# Access Compliance Report

## Public Rights-of-Way

### (Curb Ramps)

Intersection ID: N/A	Main Street: SOUTHMORE_DR	Cross Street: HOUSTON_FIELD_CT	Location: SE
ADA ID: A136EF69347A	Ramp Type: Directional1	Initial Pass/Fail: Fail	Overall Compliance: No
		Severity Score: 25

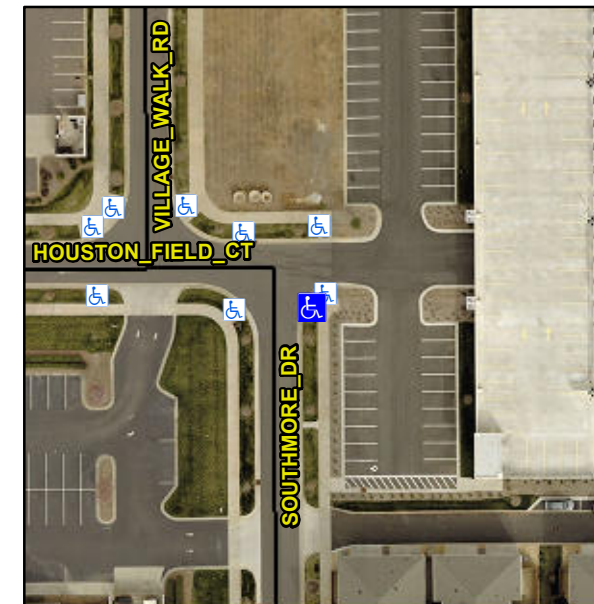
**R304.2.2, R304.5.3**

Compliance	Description	Data	Compliance	Description	Data
N/A	Ramp Length (in)	80.0	N/A	Grade Break?	N/A
Yes	Ramp Width (in)	70.0	N/A	Grade Break Slope (%)	0.0
No	Ramp Slope (%)	8.6	N/A	Grade Break XSlope (%)	0.0
No	Ramp XSlope (%)	5.4			
N/A	Flare Type LT	N/A	N/A	Flare Type RT	N/A
N/A	Flare Slope LT (%)	N/A	N/A	Flare Slope RT (%)	0.0
N/A	Flare Traversable LT?	N/A	N/A	Flare Traversable RT?	N/A
N/A	Landing Length (in)	0.0	N/A	DWS Provided?	N/A
N/A	Landing Width (in)	0.0	N/A	DWS Contrast?	N/A
N/A	Landing Slope (%)	0.0	N/A	DWS Length (in)	N/A
N/A	Landing X Slope (%)	0.0	N/A	DWS Full Width?	N/A
N/A	Landing Curb? (Y/N)	N/A	N/A	DWS Offset LT (in)	N/A
N/A	Shared Landing?	N/A	N/A	DWS Offset RT (in)	N/A
N/A	Gutter Ponding?	0.0	N/A	Gutter Slope (%)	N/A
N/A	Gutter Lip Ht (in)	0.0	N/A	Gutter X Slope (%)	N/A
N/A	Painted X Walk1?	No		Road Slope (%)	1.4
	X Walk 1 Direction	To W		Road X Slope (%)	1.0
	X Walk 1 Width (in)	N/A		Clear Space?	N/A

X Walk 1 Slope (%)	1.4	N/A	Clear Space to XWalk (in)	N/A
	X Walk 1 X Slope (%)	1.0	N/A	Storm Grate/Utility Hazard?	N/A
N/A	Ramp inside XWalk1?	N/A		Storm Grate/Utility Type	
N/A	Any Obstructions?	N/A			N/A
	Obstruction Type		Yes	Surface Condition? (G/P)	Good
			N/A	Curb Slope (%)	11.2

**Remove & Replace Entire Ramp.**
